FIELD CHANGE ORDER NO. 3

Project Name: Holiday Inn, North St, and Farlow Ave Water Main Reconstruction
Project No.: W07-1631 CIP No.: 50465

FIGURE 1

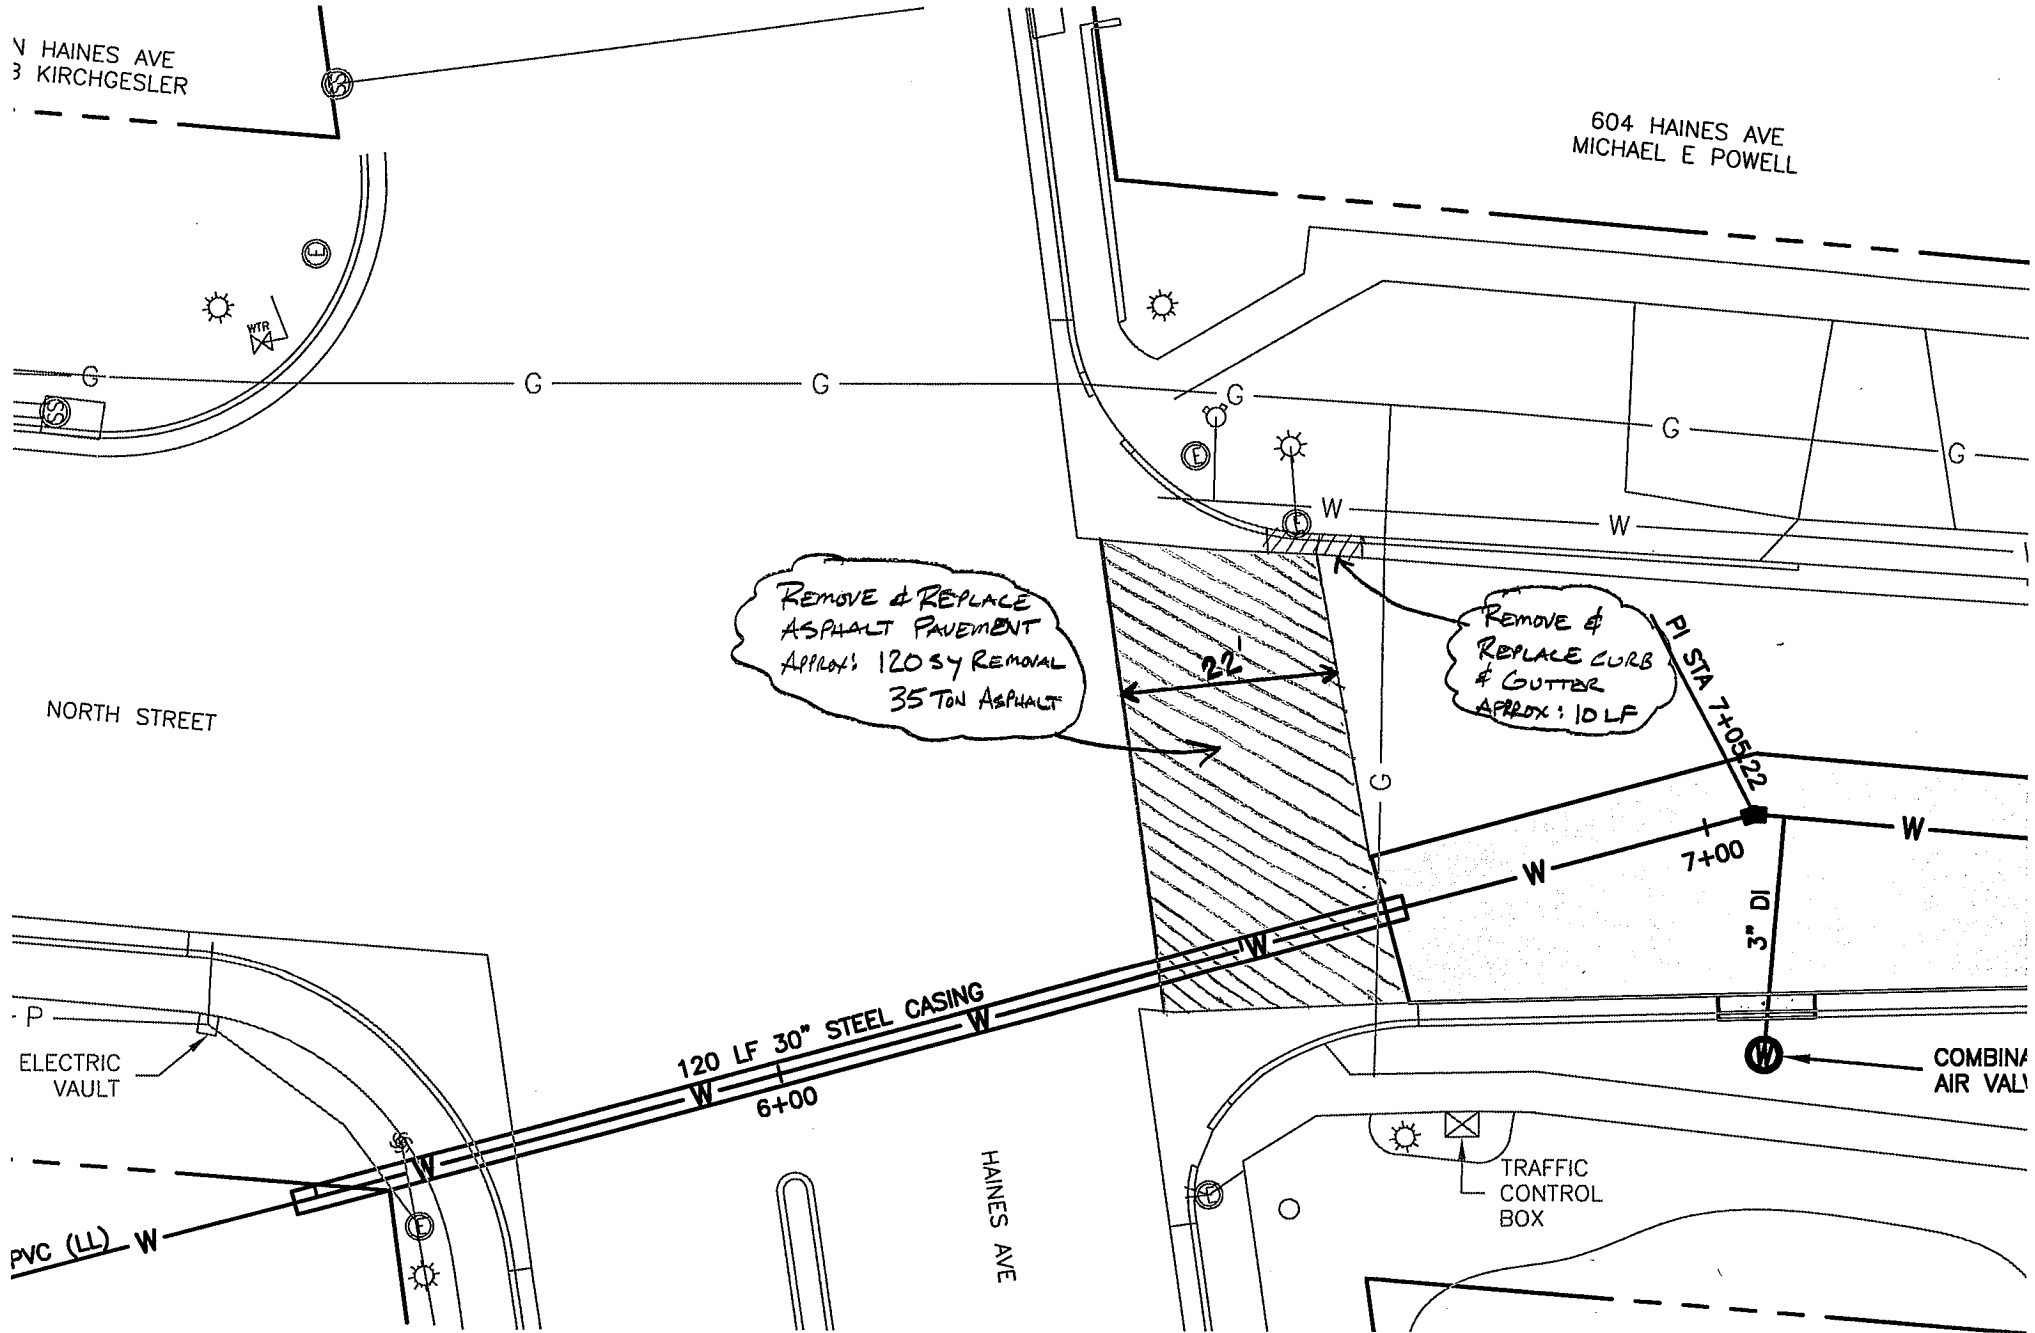
Remove remaining concrete approach and driveway and replace with curb and gutter; delete replacing concrete approach and driveway. Place sod between the back of curb and the sidewalk.

The City Traffic Department requested the pavement work at the corner of Haines Avenue and North Street. The traffic loops need replacement and it would be a very convenient time to make these repairs while the adjacent pavement is already partially removed. The City Traffic Dept will install the new traffic loops and restore the pavement markings. The City Utility Maintenance Department requested the existing 6" gate valve at the corner of Anamosa Street and Dilger Avenue be removed and the 6" water main repaired. This valve is adjacent the water transmission main being abandoned by this project and is no longer needed.
